MEMORANDUM

Subject: Approval floorplans

The Volusia County Transform386 Single Family Repair and Replacement Program, aka Homeowner Recovery Program, in conjunction with its implementation vendor, LEMOINE Disaster Recovery, is proposing authorization of the following to the available floorplans offered through the program:

X-6402E (w/ HALF PORCH) - (PRELIM-021926-CODY)
2-BEDROOM / 2-BATH

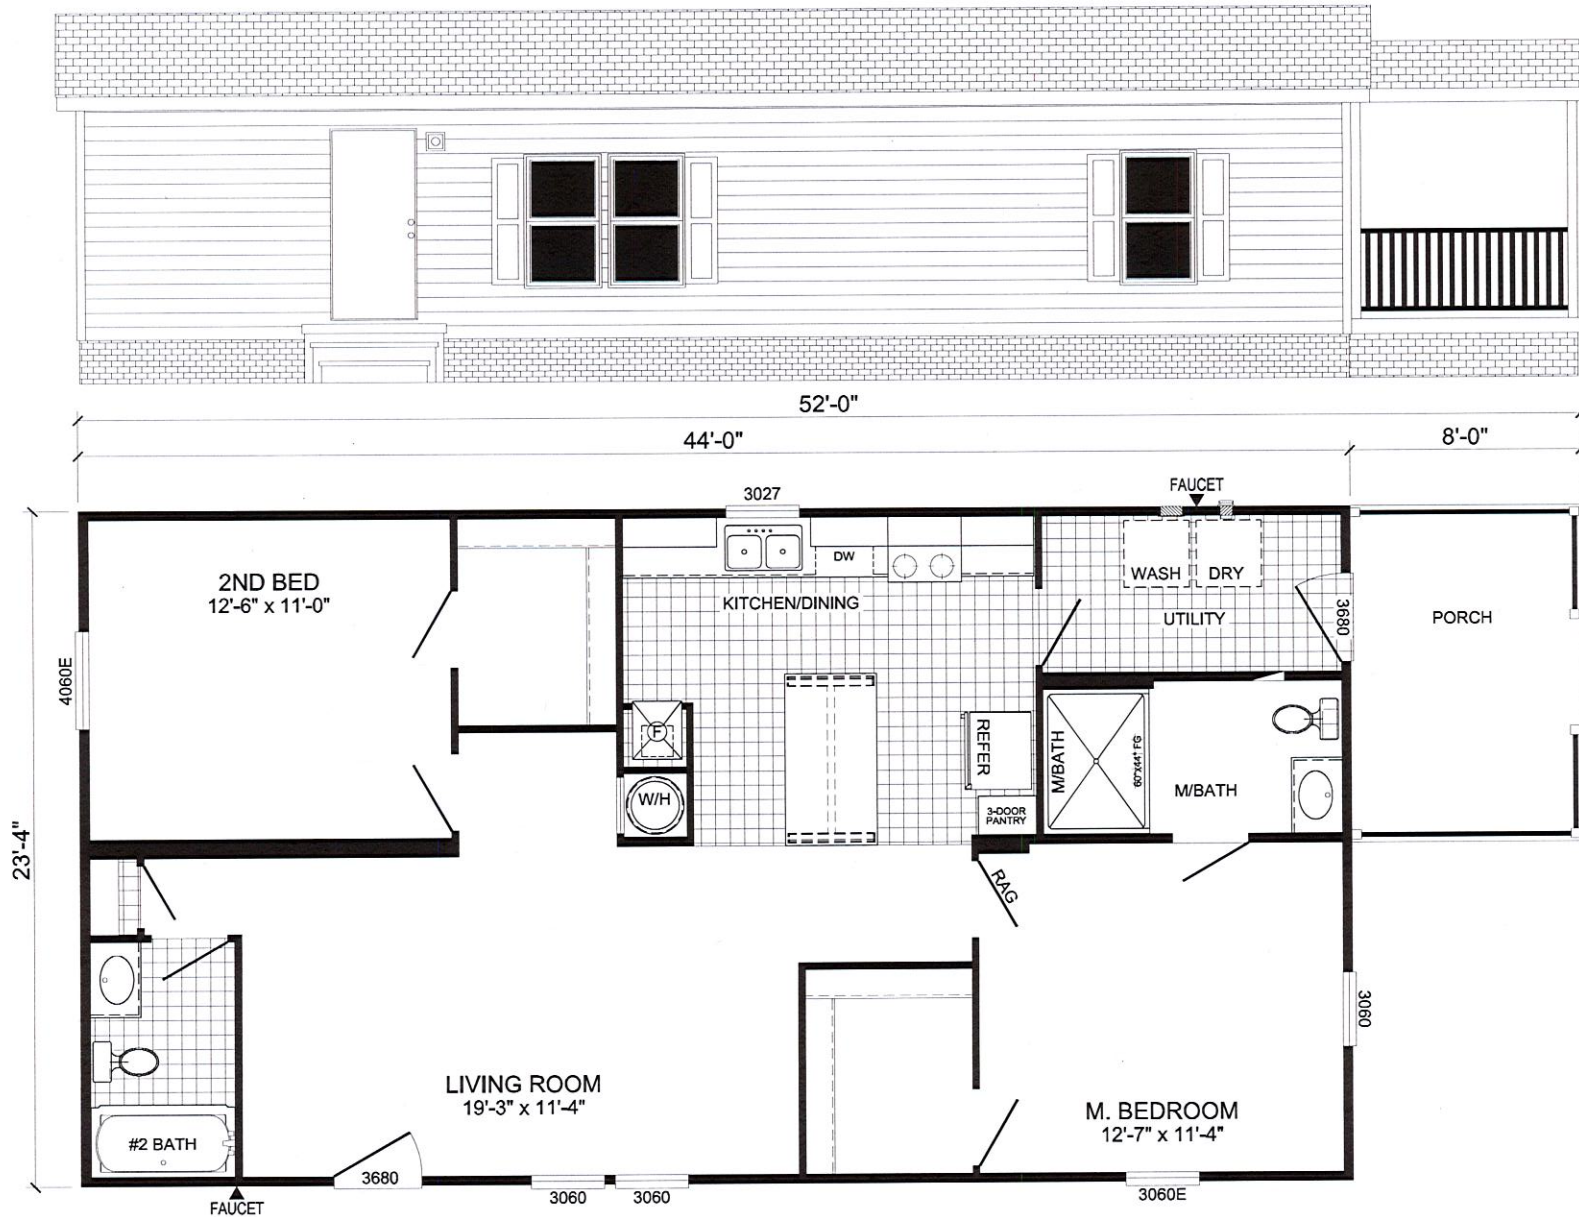
- Add Doublewide 2 bedroom / 2 bathroom X-6402E plan from Live Oak at a cost of \$145 per square foot, including the optional porch for use when required
- Remove the Doublewide 2 bedroom / 2 bathroom Mill Creek 2, non-ADA, plan from Live Oak.

The replacement of the Mill Creek 2 plan with the X-6402E is the result of a LEMOINE request to allow for a narrower, more versatile Live Oak unit for lot constraints as well as to include a manufacturer provided porch for when park or jurisdictional requirements include a porch.

All the same, I am requesting the approval of the attached 2/2 DW for use on Transform 386 Replacement Projects. The intent is for this new floorplan to replace the approved "Mill Creek 2". The new version is narrower, more versatile, and allows for more flexibility on tight lots with required improvements like we see in Mobile Home Parks. The door placement on the left elevation has also been moved further back to prevent stairs, ramps, and lifts interfering with the carport / driveway area, making it more usable for the homeowner. This new floorplan fits within the approved SF range for 2/2 DW MHUs (1000 - 1250).

Mill Creek 2 (non ADA)

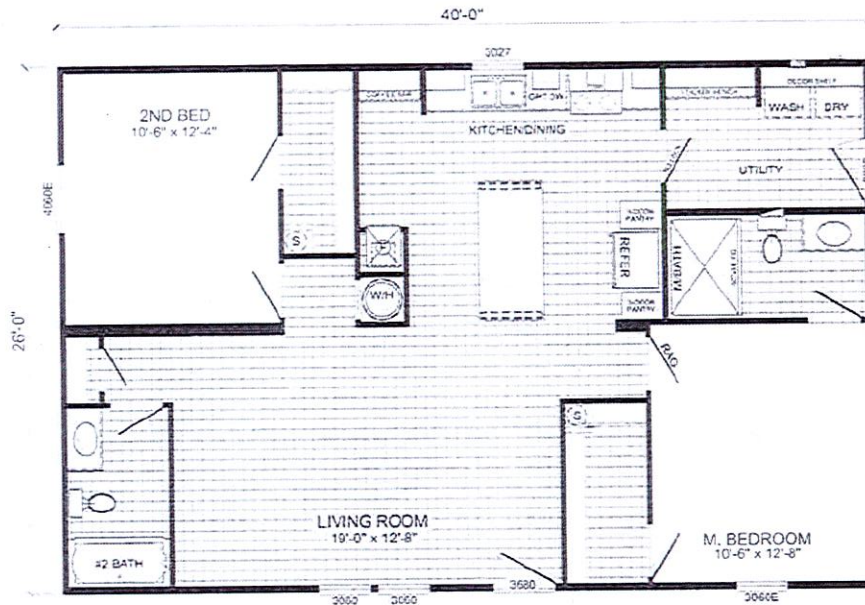
Additionally, I have attached the site plan and STEP deficiency report from COPO for project 2503030001_Smith. We are attempting to use the approved Mill Creek 2 floorplan (26' width), but it is too wide and does not meet the minimum separation between structures for this property in COPO. The approval of this alternate floorplan would help alleviate these types of issues in the future.
